## ADDENDUM NO. 2

CITY OF WILLCOX  
WASTEWATER TREATMENT PLANT  
SINGLE LINE DIAGRAM 1 OF 2  
ELE-MCC-005

CITY OF WILCOX  
WASTEWATER TREATMENT PLANT  
ELECTRICAL PLAN - BLOWER/ELECTRICAL BUILDING  
WILSON PROJECT NO. 11004

Sheet No. I-2.18

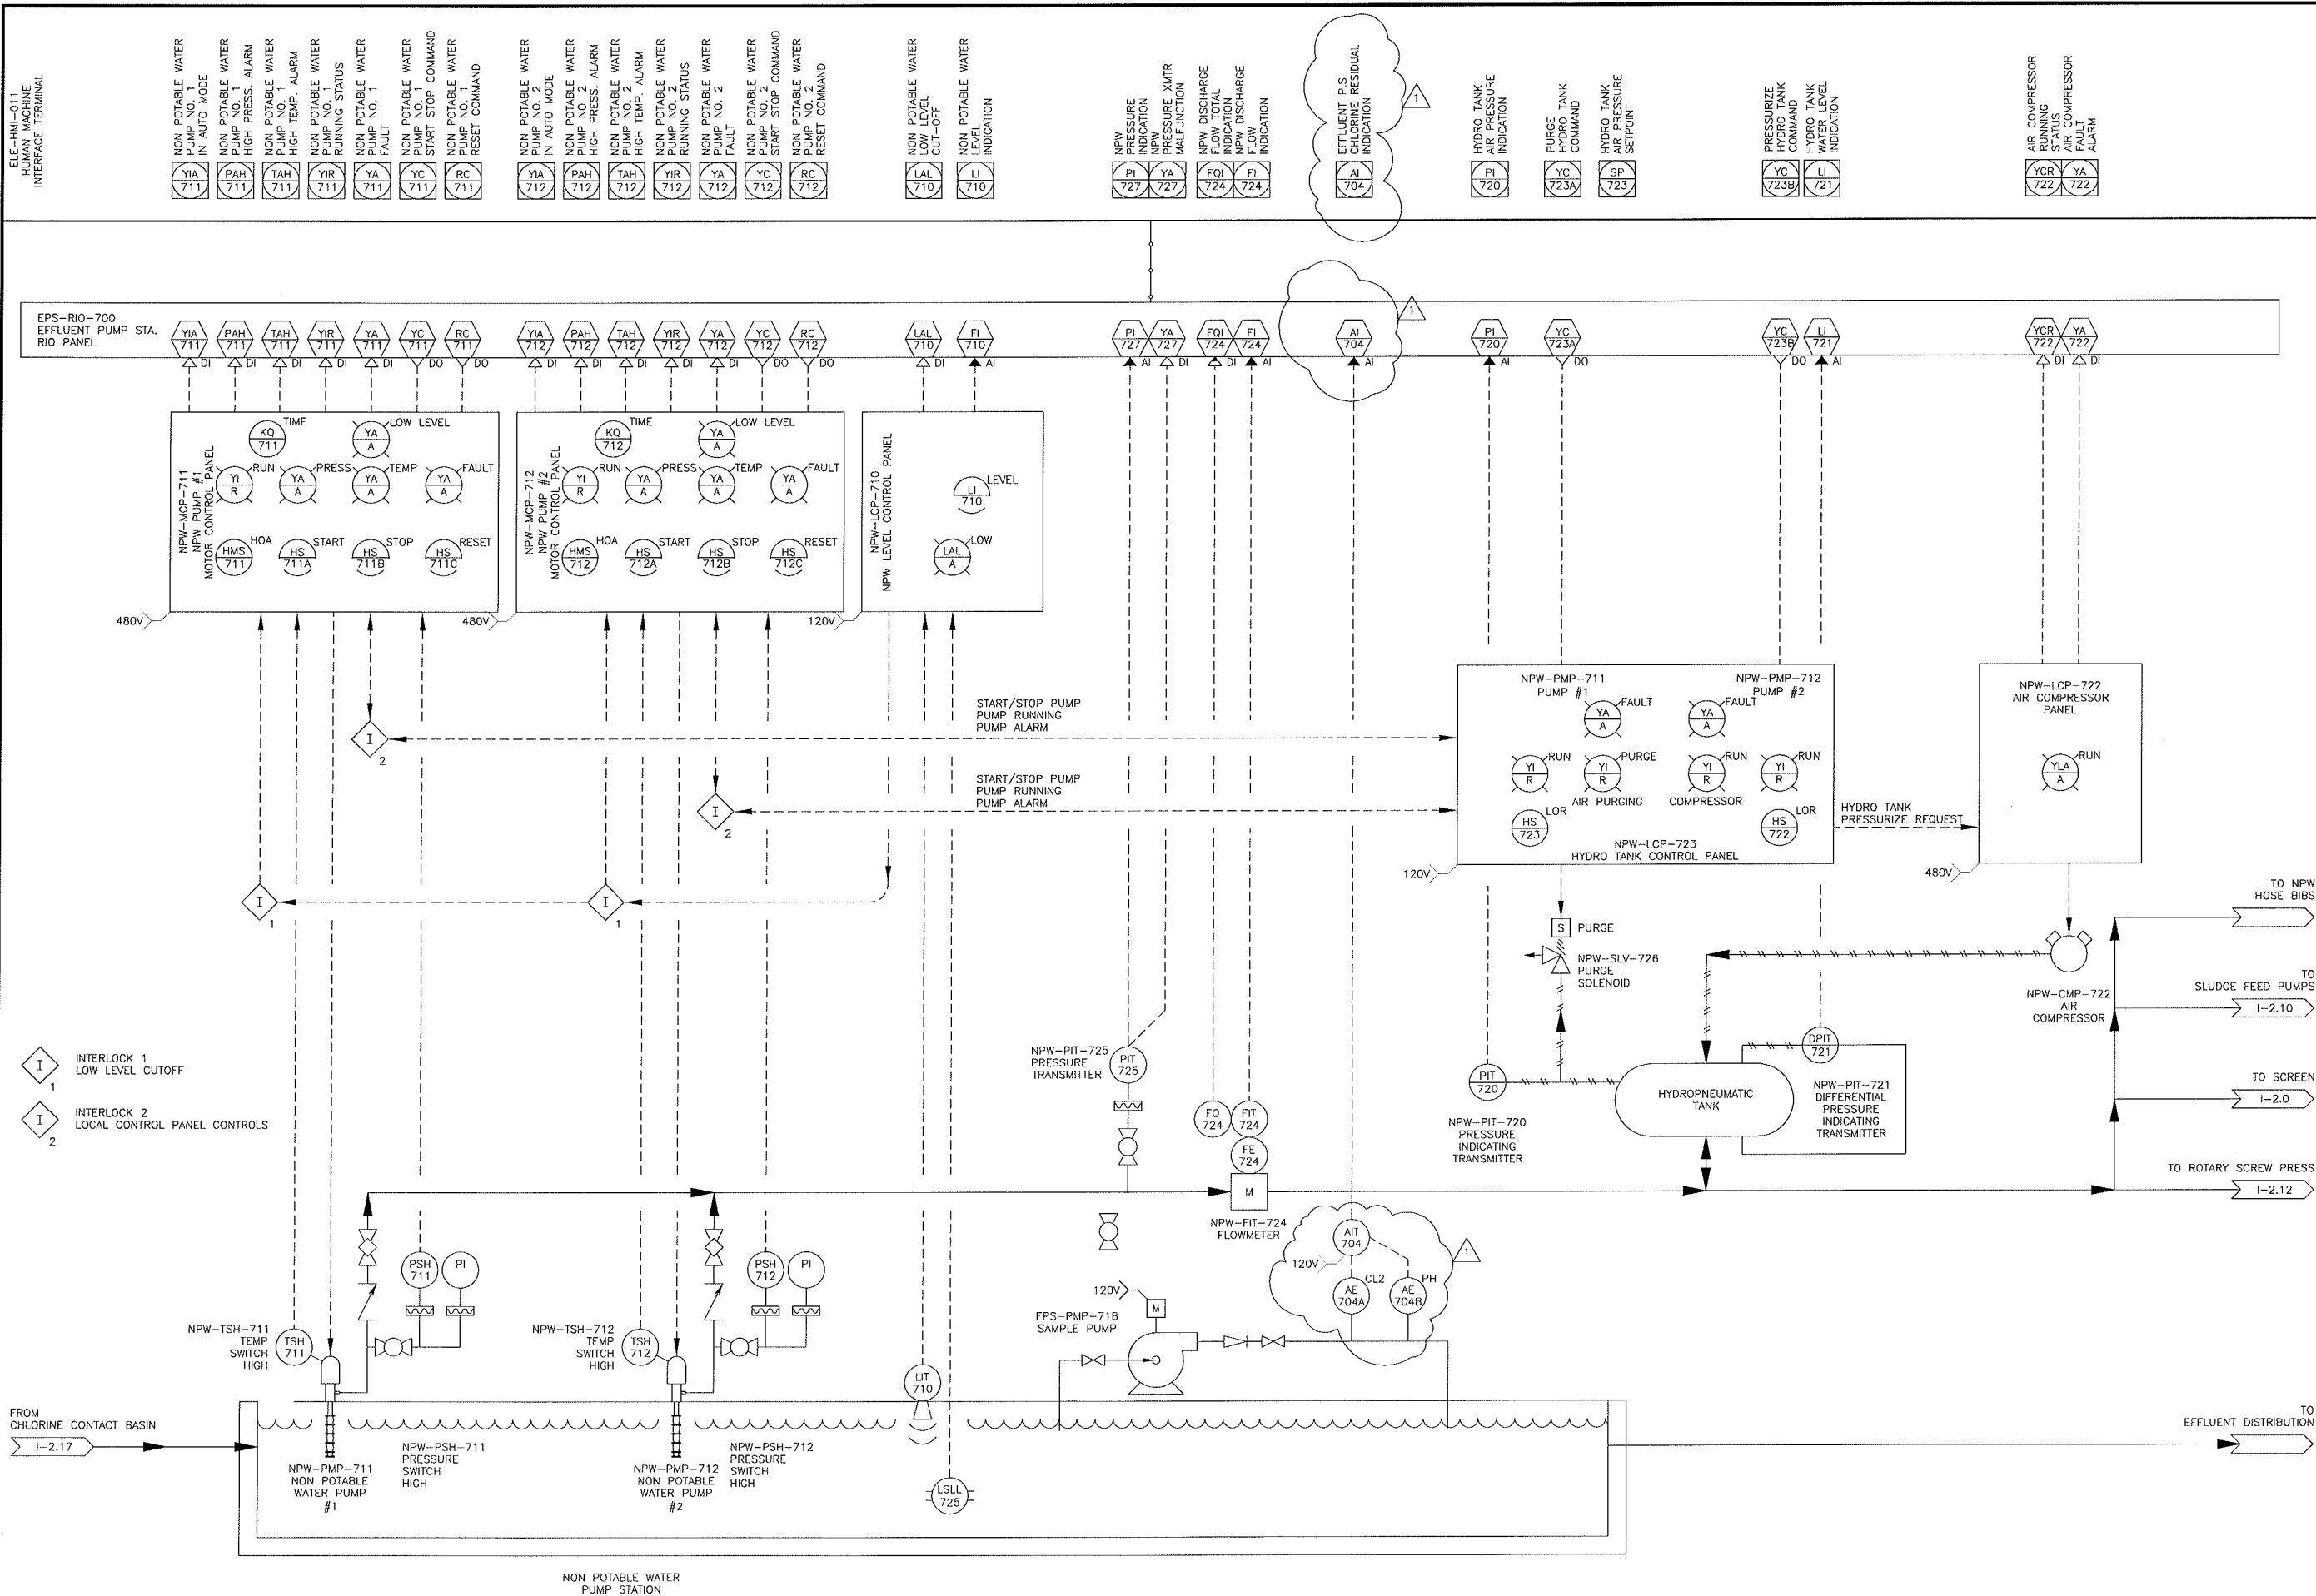
21. **Question:** Sheet E-3.15, key note 19 and Sheet I -2.18, show the EPS-AIT-717. The conduit block diagram doesn't show AIT-717. Please provide the conduit number with the conduit size and wires required for this instrument.

**Response:** See **DRAWINGS:** Items 12 and 13 below. Sheet E-3.15, Item 19 and Sheet I-2.18 revised to read "EPS-AIT-704 to match CBD and Panel Schedule.

- c. **REPLACE** Drawing I-2.18 with Revised Drawing I-2.18.
- d. **REVISED** “EPS-AIT-717” to read “EPS-AIT-704”.
